PLANNING DEPARTMENT – Development Review Services

**RE: Winrock Redevelopment Parking Structure
Drainage Report
Grading Plan for Grading Permit
Engineer's Stamp Date 3-7-2015 (J19D058C)**

Based upon the information provided in your submittal received 3-9-15, the above referenced plan is approved for Grading Permit with the following condition:

DATE 03/06/15	SHEET C103
SCALE 1"=100'	of XX

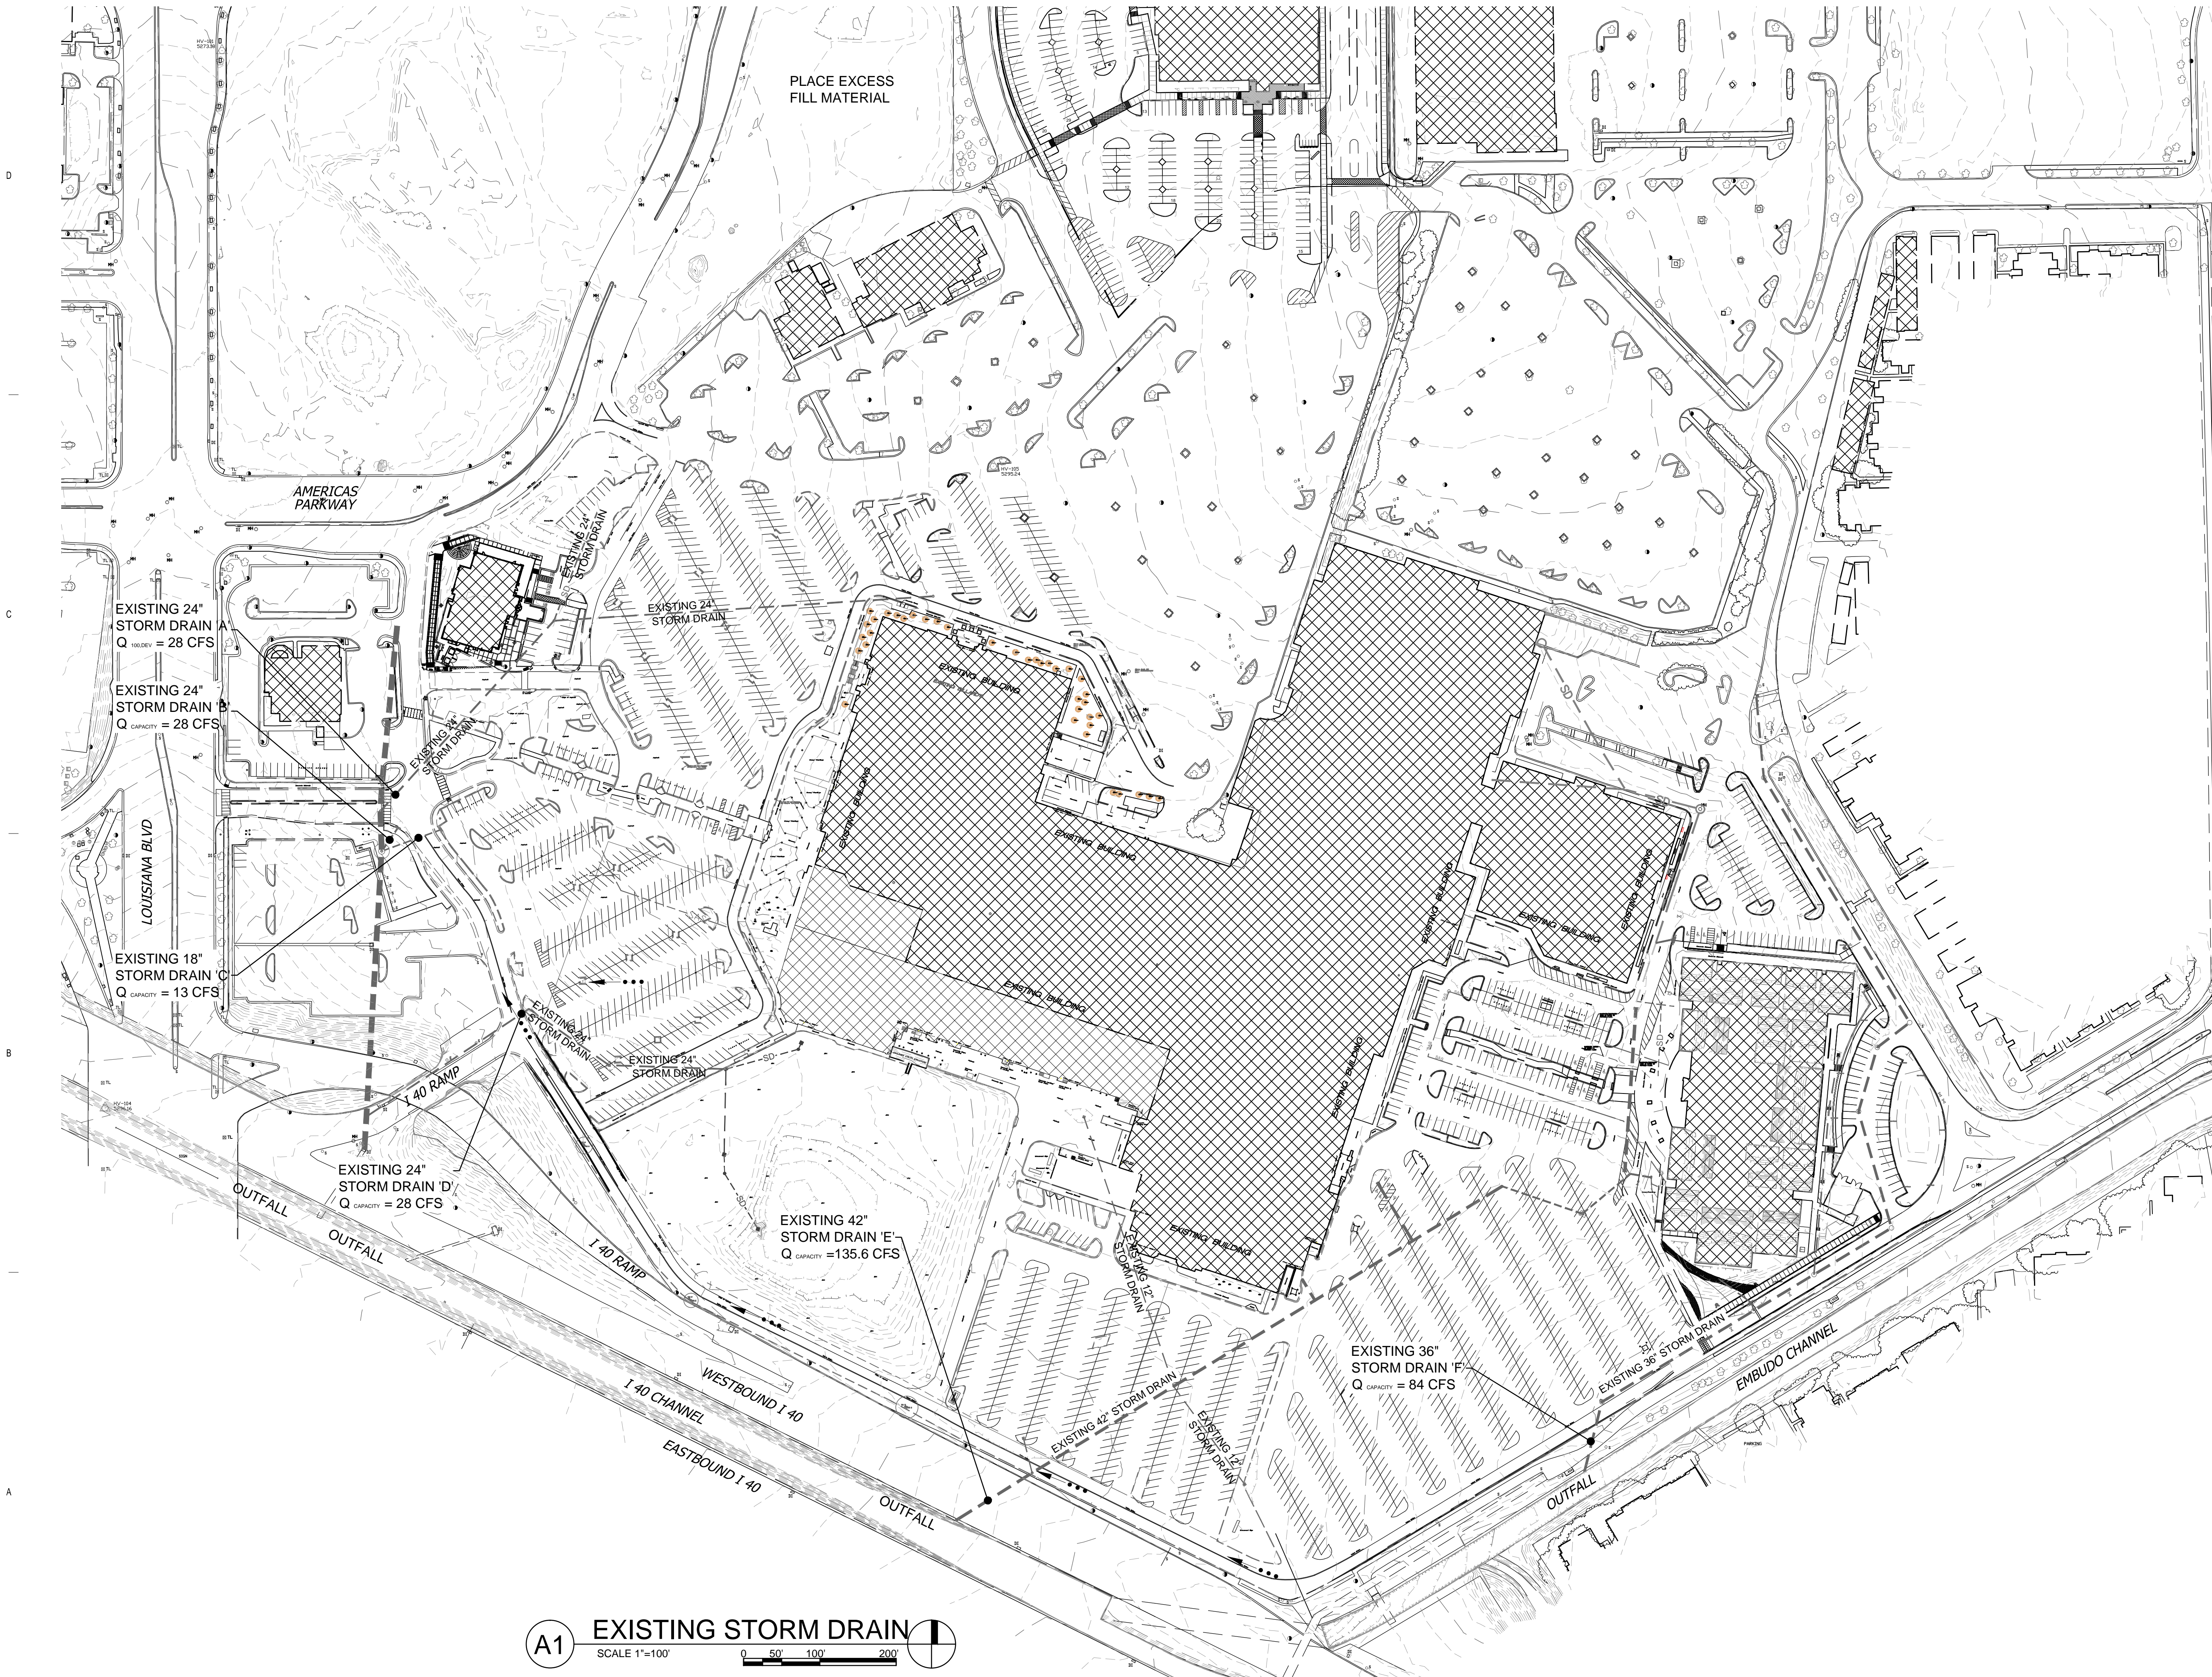
- Winrock Development on the overall site is being constructed in phases. All interim phases must limit the runoff to any one of the discharge points to less than the existing capacity shown on sheet C-103.
- In the interim phases, the total proposed runoff to the 3 discharge points must be less than or equal to the total existing discharge at those same points.
- The interim phases must comply with the overall concept of the Master Drainage Plan.

- Winrock Development on the overall site is being constructed in phases. All interim phases must limit the runoff to any one of the discharge points to less than the existing capacity shown on sheet C-103.
- In the interim phases, the total proposed runoff to the 3 discharge points must be less than or equal to the total existing discharge at those same points.
- The interim phases must comply with the overall concept of the Master Drainage Plan.
